CERTIFICATE OF APPROPRIATENESS

ITEM B8 November 5, 2026 1235 Allston Street
HPO File #: HP2026_0308 Houston Heights West

Proposal: Alteration – Addition

The applicant proposes to construct a two-story addition to the rear of a one-story home.

Existing Metal Windows and Vinyl Siding

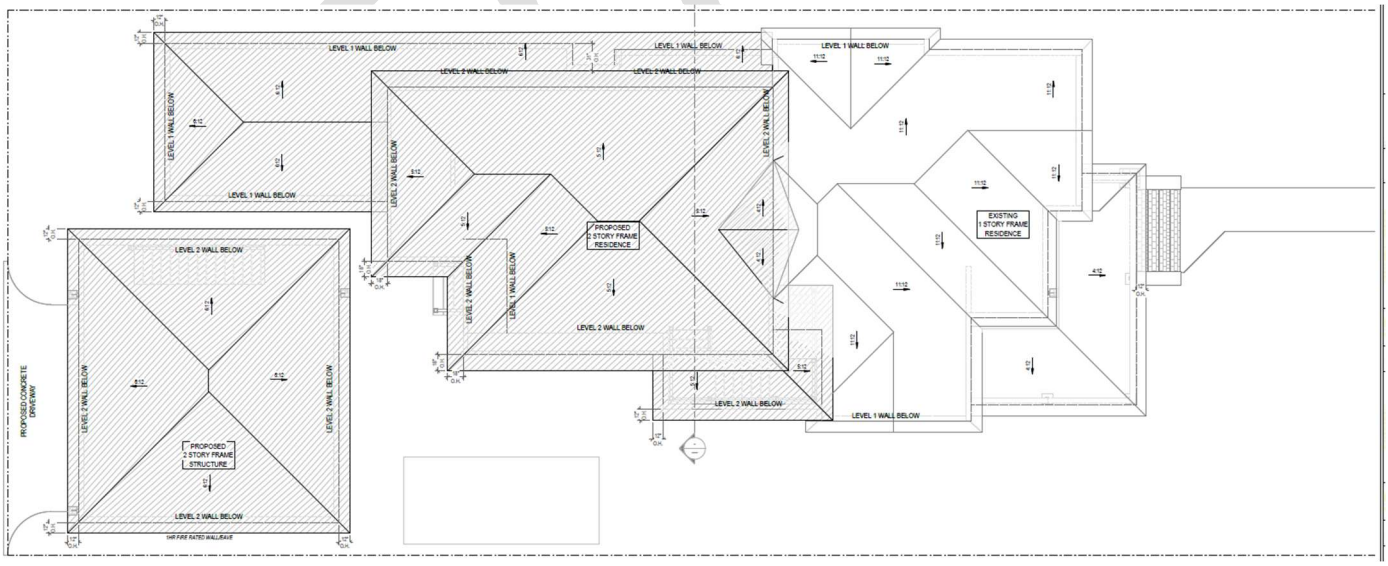
- 10 existing metal windows will be replaced with new wood, 1-over-1, double hung wood windows to match the original openings. The original openings are largely obscured by siding and wall finishing and staff will verify size and location after demo reveals original openings.
- Non original porch enclosure will be removed to restore the previous wrap-around porch.
- Non-original rear addition to be removed.
- Existing 1,576 square foot home will consist of 2,852 square feet with the proposed addition.
- Addition will feature an eave height of 22' (7' side setback) and a ridge height of 28' 9".
- All new windows need to be inset and recessed. See Attachment A for details.

Recommendation: **Approval With Conditions-Staff to verify previous window openings during construction**

ATTACHMENT A

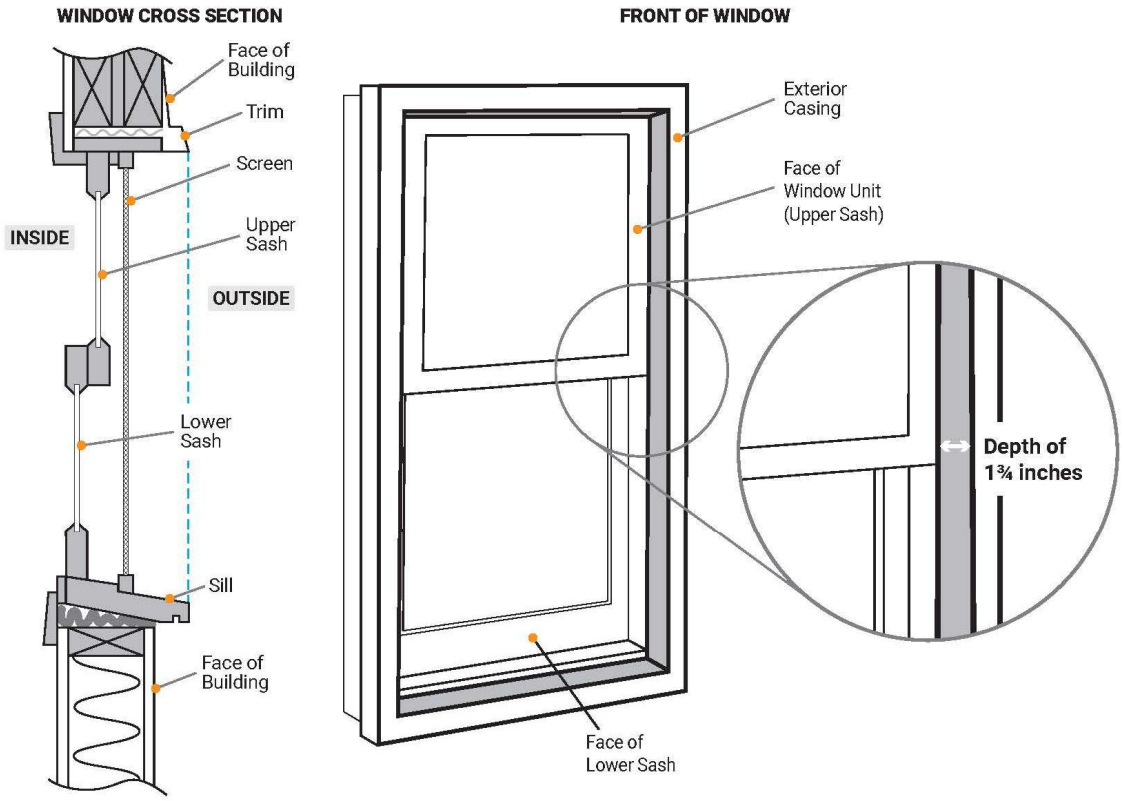
- Depth from Exterior Casing to the Face of the Window Unit (Upper Sash)
- Windows must be 1-over-1 (equally horizontally divided)
- 1¾ inch minimum inset for Fixed Window
